Product Information Notification

Product Group: DI/Mon Nov 20, 2023/PIN-DI-00622-2023-REV-0

IHLP-6767 Width Tolerance Correction

Datasheet updates:

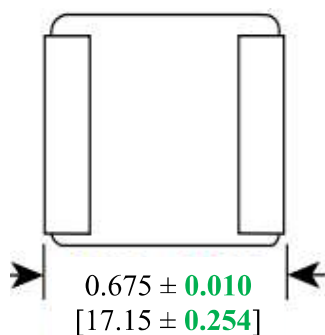
Description of Change: The tolerance on the overall part width (terminal-to-terminal) for all IHLP6767* inductors is being corrected from $\pm 0.005"$ to $\pm 0.010"$ to resemble the tolerance listed on most other IHLP products. There are no changes to the part or the manufacturing process. Please see image on following page for more information.

Reason for Change: Datasheet being corrected to reflect observed manufacturing tolerances.
